TECHNICAL INFORMATION

Product Name Nikon FM2/FE2/FA

Ref. No. FM2-840024

SHUTTER IMPROVEMENTS

Figure 1

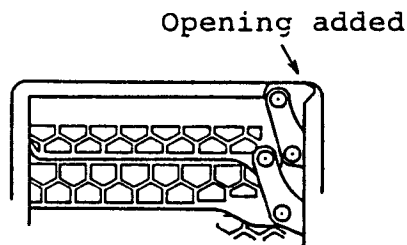
1. Modification of inner aperture frame from July 1982

The upper wind-side corner of the inner aperture frame has been re-contoured to prevent the interference with the edge of closing curtain that travels with shaking between the aperture frames. See Figure 1.

Figure 2

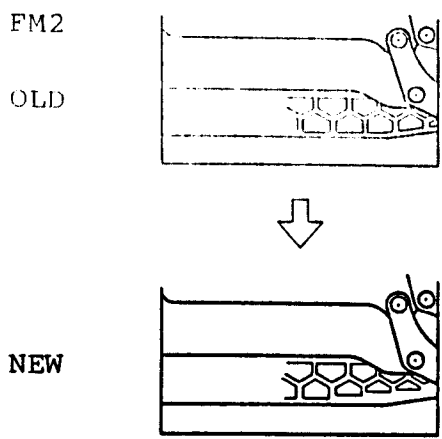
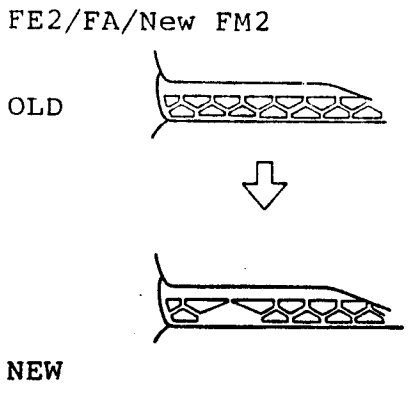
2. Modification of honeycomb structure from August 1982

One part of the honeycomb structure has been changed to reinforce the blade of closing curtain. See Figures 2 and 3.

Figure 4

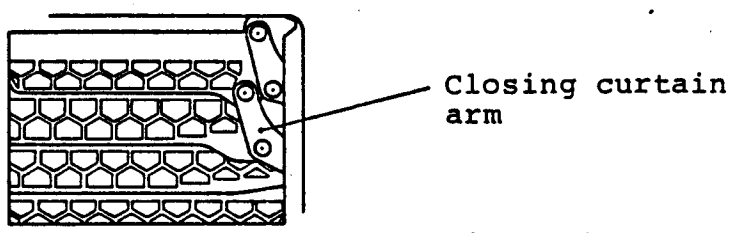
3. Change of material for closing curtain arm from February 1983

The material of closing curtain arm has been changed from titanium into carbon steel for reinforcement. See Figure 4.

Figure 5

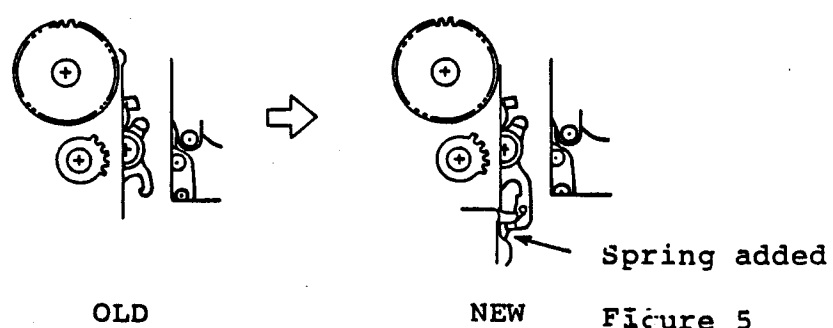
4. Improvement of closing curtain brake from May 1983

A spring has been added to the closing curtain brake to increase the efficiency of braking. But this has not been applied to the former FM2 camera. See Figure 5.

Figure 6

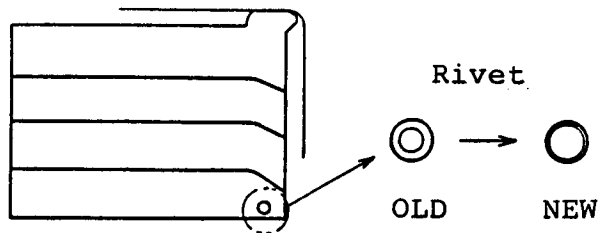
5. Modification of rivets securing the blades from December 1983

The rivets have been modified to prevent dislocation of shutter curtain blades. See Figure 6.

Figure 7.

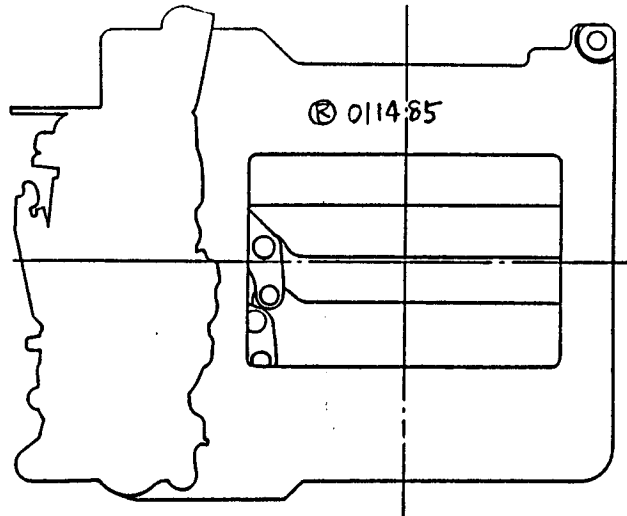
4. Use a pencil to write the mark " (R) " and the date of repair on the aperture plate. It will give a reference for future repair. See Figure 7.
